Access Compliance Report

Public Rights-of-Way

Intersection ID: 7966	Main Street: PAWTUCKETT_RD	Cross Street: SWIFT_ARROW_LN	Location: S
ADA ID: 65821454D1C6	Ramp Type: Perpendicular	Initial Pass/Fail: Fail	Overall Compliance: No
Severity Score: 12.5			
Codes/Mitigation Info/Possible Solution		Field Measurements/Component Compliance

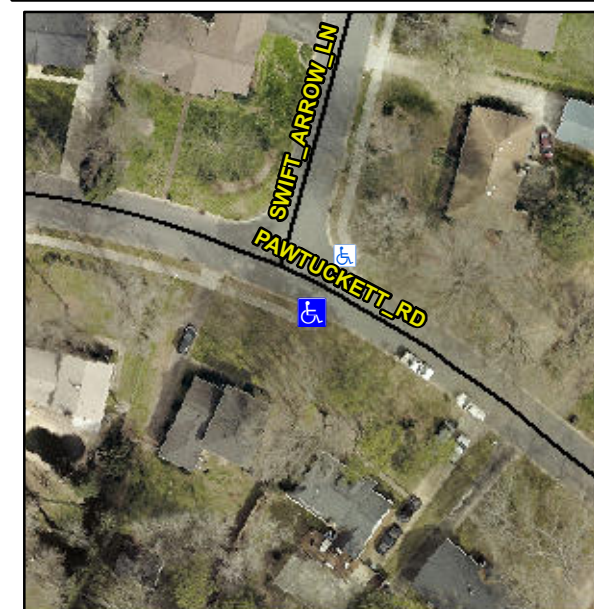
Not Found, R304.2.2

Remove & Replace Entire Ramp.
